## **SECTION C: CONSOLIDATED TENDER COMMUNICATIONS**

**Re: Rotorua Lakefront Redevelopment Stage 1 & 1a – Contract Award.**

**Re: Rotorua Lakefront Redevelopment Stage 1 & 1a – Notification of Preferred Contractor Status.**

Scale	Drawing Title	
1:200	Stage 1 Temporary Works Plan - Sheet 3	
Job No	Drawing Number	Revision
4010	1_1.003	D
North	Issued For	
A	Tender

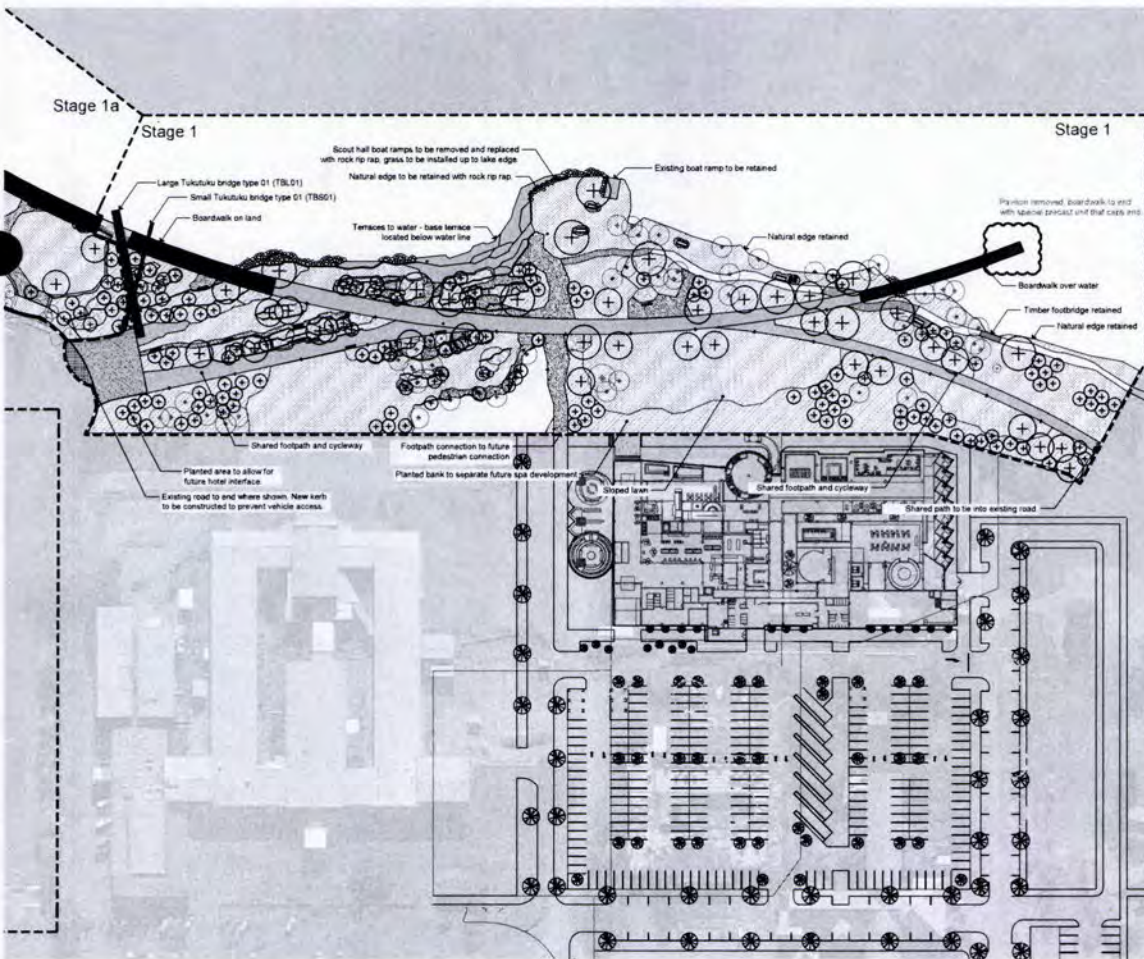
7.7	Pavilion Design	<p>Please see attached revised pavilion design.</p> <ul style="list-style-type: none"> <li>1_1.003 Stage 1 Temporary Works Plan - Sheet 3</li> <li>1_1.100 Stage 1 General Arrangement</li> <li>1_1.103 Stage 1 Surface Finishes - Sheet 3</li> <li>1_1.203 Stage 1 Planting Plan - Sheet 3</li> <li>1_1.303 Stage 1 Furniture &amp; Edging - Sheet 3</li> <li>1_1.403 Stage 1 Levels Plan - Sheet 3</li> <li>1_3.401 Pavilion Plans</li> <li>1_3.402 Pavilion Details</li> <li>1_3.403 Pavilion Stone Pattern Layout</li> <li>1_3.404 Pavilion Elevations &amp; Wall Cutting Plan</li> <li>1_3.405 Pavilion Stone Cutting Plan</li> <li>1_3.508 3000mm Boardwalk Details</li> <li>1_3.516 3000mm Boardwalk B06 Details Sheet 1</li> <li>1_3.517 3000mm Boardwalk B06 Details Sheet 2</li> <li>1_3.518 3000mm Boardwalk B06 Details Sheet 3</li> <li>1_3.519 3000mm Boardwalk B06 Details Sheet 4</li> <li>1_3.520 3000mm Boardwalk B06 Details Sheet 5</li> <li>190826_IGL_4010_Rotorua Lakefront Development_Boardwalk B06 Details dwg</li> <li>190826_IGL_4010_Rotorua Lakefront Development_Landscape Master dwg</li> </ul> <p><a href="https://www.dropbox.com/sh/10foxa8lthcjzcc/AADPztQtXKaUHQRryiYd-Uqaa?dl=0">https://www.dropbox.com/sh/10foxa8lthcjzcc/AADPztQtXKaUHQRryiYd-Uqaa?dl=0</a></p> <p>The revised pavilion design attached reduce the scope of the pavilion significantly.</p> <p>Updated Tonkin &amp; Taylor engineering drawings are expected to be issued mid next week.</p> <p>Please advise cost and programme saving for amended design.</p>

Scale Drawing Title  
**AS SHOWN Samples Schedule Sheet 2**  
 Job No Drawing Number Revision  
**4010 1\_0\_304 C**  
 Issued For  
**Tender**

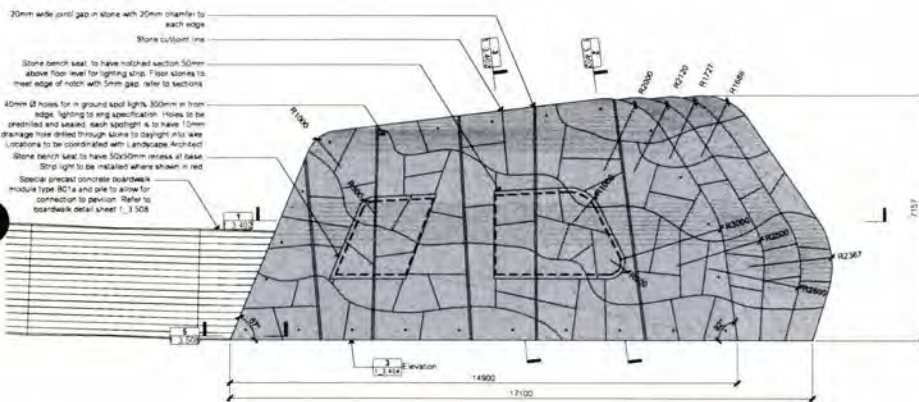
5.3	N/A	Architectural samples	<p>The architects have further refined/ reduced the sampling requirements in order to reduce cost and to align with finishes available via Firth.</p> <p>Please see attached revised drawings: 1_0.301 Paving, Edge &amp; Wall Schedule 1_0.303 Samples Schedule Sheet 1 1_0.304 Samples Schedule Sheet 2</p> <p>Also note the following in regards to sampling: <u>Tukutuku timber edge profiles and finish</u> - recommend we agree with contractor to inspect first section, no prototype required. <u>Seating bench and table</u> - recommend we agree with contractor to inspect elements throughout fabrication ie, first steel section, first cut of timber, first finished seat. <u>Light poles</u> - recommend we agree with contractor to inspect first finished pole Ladder - recommend we agree with contractor to inspect first ladder <u>Bollard</u> - this is a simple design, no prototype needed.</p> <p>Please advise any associated cost savings.</p>

5.3	N/A	Architectural sampling	The architects have further refined/reduced the sampling requirements in order to reduce cost and to align with finishes Please see attached revised drawings 1.0.301 Paving, Edge & Wall Schedule 1.0.303 Samples Schedule Sheet 1 1.0.304 Samples Schedule Sheet 2 Also note the following in regards to sampling Tukitukutu timber edge profiles and finish - recommend we agree with contractor to inspect first section, no prototype required. Seating bench and table - recommend we agree with contractor to inspect elements throughout fabrication ie. first steel section, first cut of timber, first finished seat Light poles - recommend we agree with contractor to inspect first finished pole Ladder - recommend we agree with contractor to inspect first ladder Bollard - this is a simple design, no prototype needed Please advise any associated cost savings	The sampling schedule forwarded with C005 appears to have the same quantity of sampling required as per the schedule sent with C004. The schedule has been changed to match the available mix designs offered by HEB in C004. Item 10.1 in our schedule of prices allowed for the concrete paving, edge beams, wall, precast boardwalk and decking and aggregate samples only as per the schedules provided with C004. There would be a cost saving of \$34,333.20 if the precast samples can be used in the permanent works Agreed, there was no allowance for prototypes in our tender offer Agreed, there was no allowance for prototypes in our tender offer Agreed, there was no allowance for prototypes in our tender offer Agreed, there was no allowance for prototypes in our tender offer Savings of \$34,333.20 if the precast samples can be used in the permanent works, item 1.10 has been updated to reflect the cost saving
